Access Compliance Report

Public Rights-of-Way

(Curb Ramps)

Intersection ID: 15340	Main Street: CHARLOTTE_DR	Cross Street: LATTIMORE_ST	Location:	S
ADA ID: 123DEA07CA76	Ramp Type: Perp	Initial Pass/Fail: Fail	Overall Compliance: No	Severity Score: 12.5
Codes/Mitigation Info/Possible Solution		Field Measurements/Component Compliance

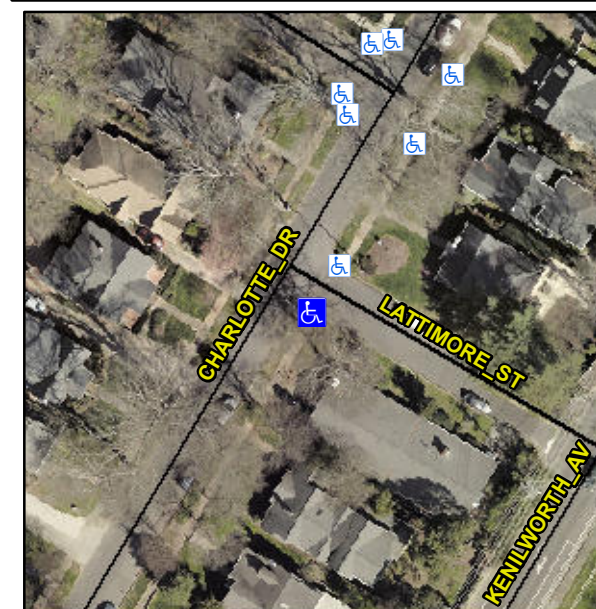
R304.2.2

Compliance	Description	Data	Compliance	Description	Data
N/A	Ramp Length (in)	66.0	No	Ramp Slope (%)	9.0
Yes	Ramp Width (in)	48.0	Yes	Ramp XSlope (%)	0.4
N/A	Flare Type LT	N/A	N/A	Flare Type RT	N/A
N/A	Flare Slope LT (%)	N/A	N/A	Flare Slope RT (%)	N/A
N/A	Flare Traversable LT?	N/A	N/A	Flare Traversable RT?	N/A
N/A	Landing Length (in)	N/A	N/A	DWS Provided?	N/A
N/A	Landing Width (in)	N/A	N/A	DWS Contrast?	N/A
N/A	Landing Slope (%)	N/A	N/A	DWS Length (in)	N/A
N/A	Landing X Slope (%)	N/A	N/A	DWS Full Width?	N/A
N/A	Landing Curb? (Y/N)	N/A	N/A	DWS Offset (in)	N/A
N/A	Shared Landing?	N/A			
N/A	Gutter Ponding?	N/A	N/A	Gutter Slope (%)	N/A
N/A	Gutter Lip Ht (in)	1.0	N/A	Gutter X Slope (%)	N/A
N/A	Painted X Walk1?	No	N/A	Painted X Walk2?	N/A
	X Walk 1 Direction	To NE		X Walk 2 Direction	N/A
N/A	X Walk 1 Width (in)	N/A	N/A	X Walk 2 Width (in)	N/A
	X Walk 1 Slope (%)	3.5		X Walk 2 Slope (%)	N/A
	X Walk 1 X Slope (%)	0.3		X Walk 2 X Slope (%)	N/A

Remove & Replace Entire Ramp.
